STAFF REPORT
COMMUNITY DEVELOPMENT DEPARTMENT

HEARING DATE: 9/8/2020
TO: Mayor & City Council
FROM: Alan Tiefenbach, Associate Planner
208-489-0573
Bruce Freckleton, Development Services Manager
208-887-2211
SUBJECT: H-2020-0086
Victory Commons Final Plat
LOCATION: The site is located at 130 E. Victory Rd. and 3030 S. Meridian Rd., in the southwest ¼ of Section 19, T.3N. R.1E.

Final Plat consisting of 4 commercial lots on 16.74 acres in the C-G zoning district. This is the first of two phases, with a total of 12 lots.

A. Preliminary Plat (date: 11/20/19)

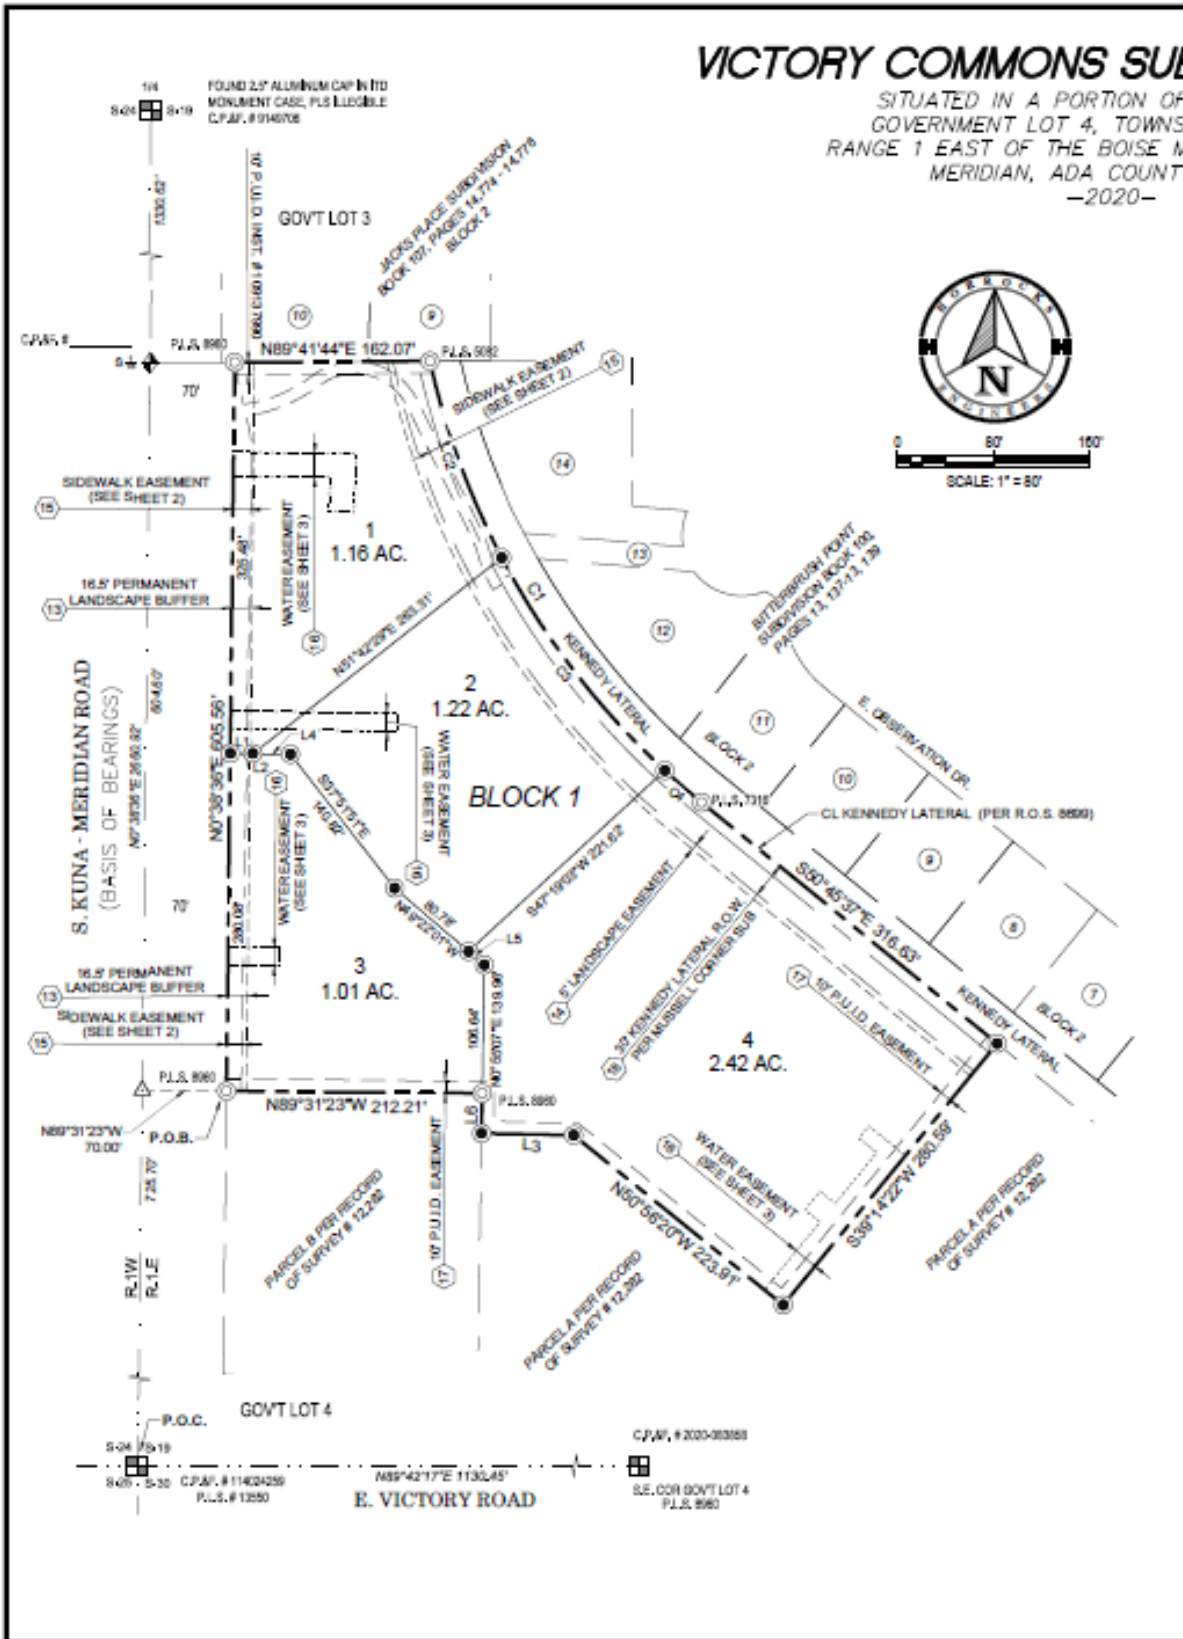
1. This phase of the development will result in a long deadend water main which may result in poor water quality. Looping the water system back to Victory Rd as shown in the Preliminary Plat will eliminate this issue.
2. Public Works Department suggests the elimination of the proposed parallel water main off of Meridian Rd by utilizing the existing water main in the driveway entrance. The proposed water meter and hydrant could be connected off of the existing water main.
3. Is the new proposed hydrant near Meridian Rd needed? There is an existing hydrant just south of the driveway entrance.

B. Final Plat (date: 6/23/2020)

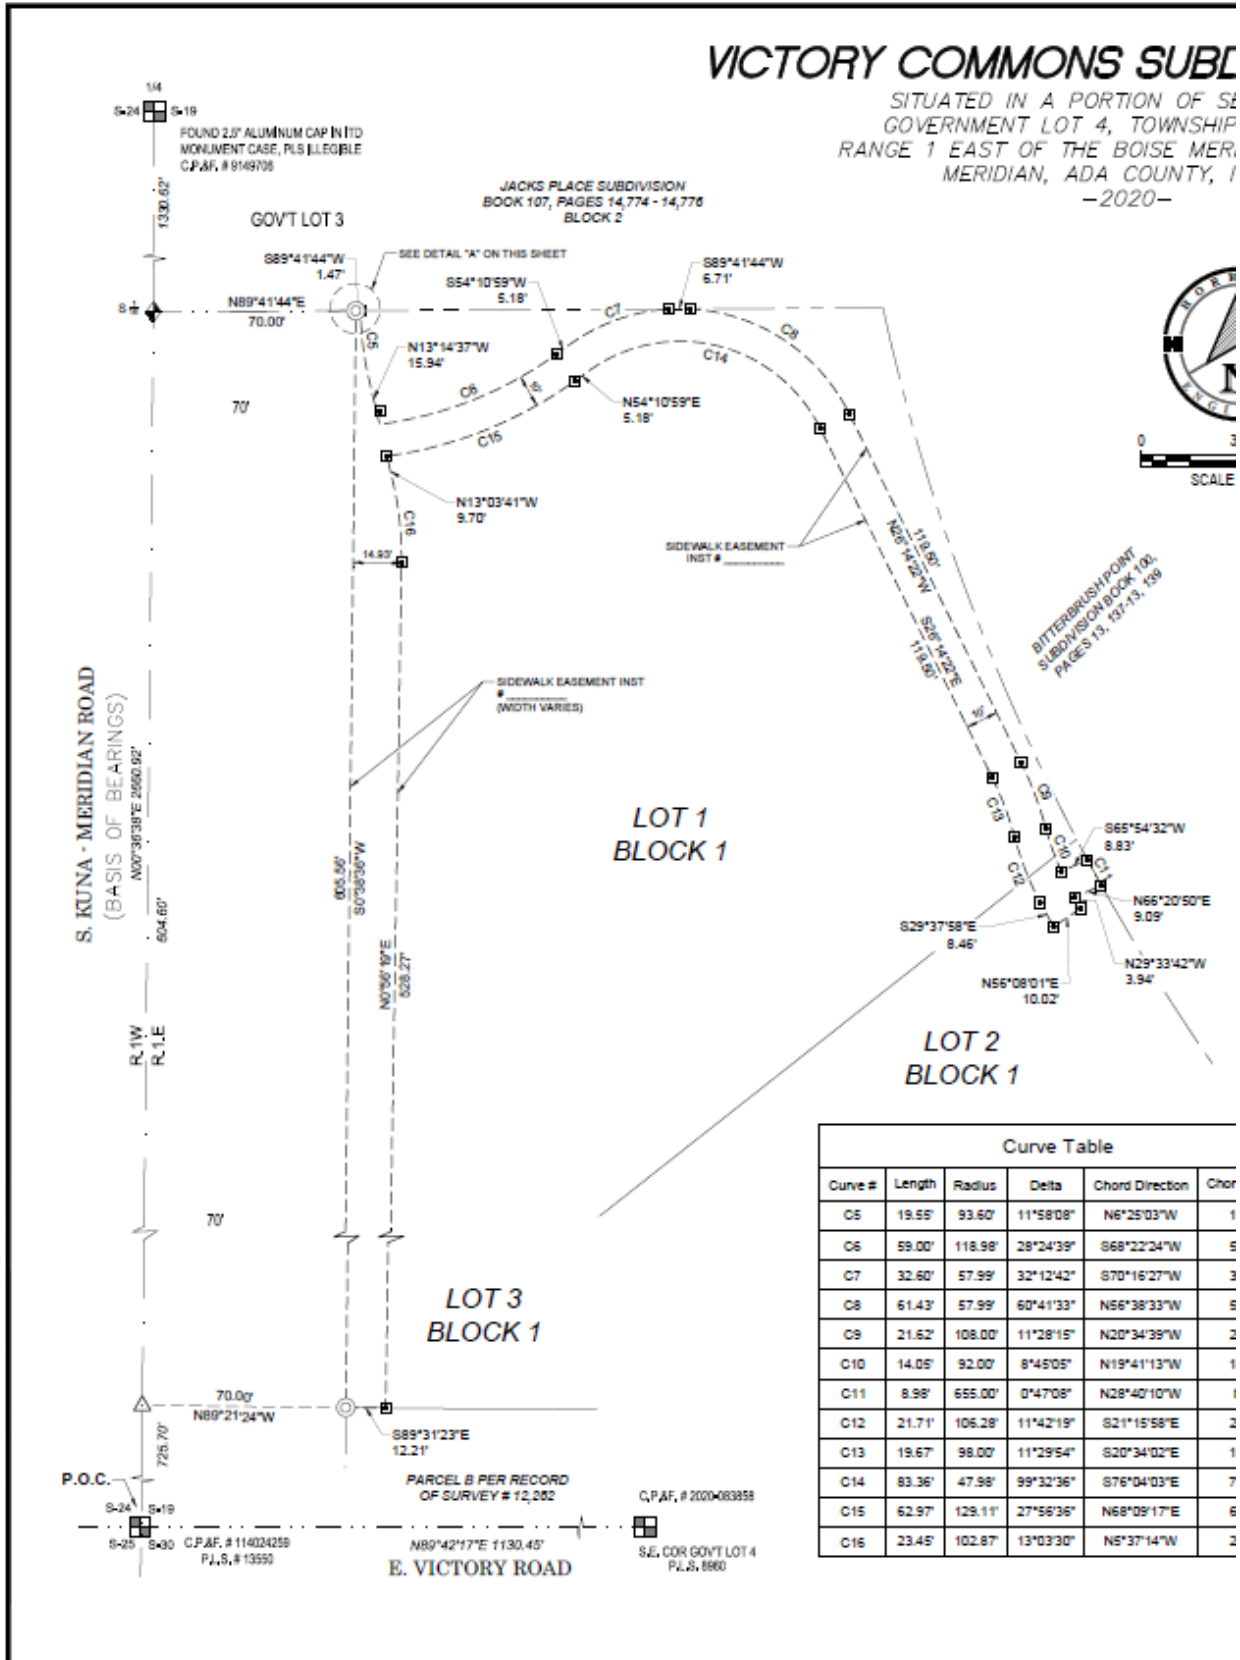
- a. On the face of the plat insert the recorded water and pedestrian easement numbers.
 - b. Note #11, 12 and 15 – insert instrument numbers.
7. The required landscape buffers along Meridian and Victory Roads shall be measured from the ultimate right-of-way as anticipated by the transportation agency in accord with UDC 11-3B-7C1.c. The applicant shall be required to obtain a ROW license agreement from ITD to install and maintain the buffer along S. Meridian Road prior to signature on the final plat.
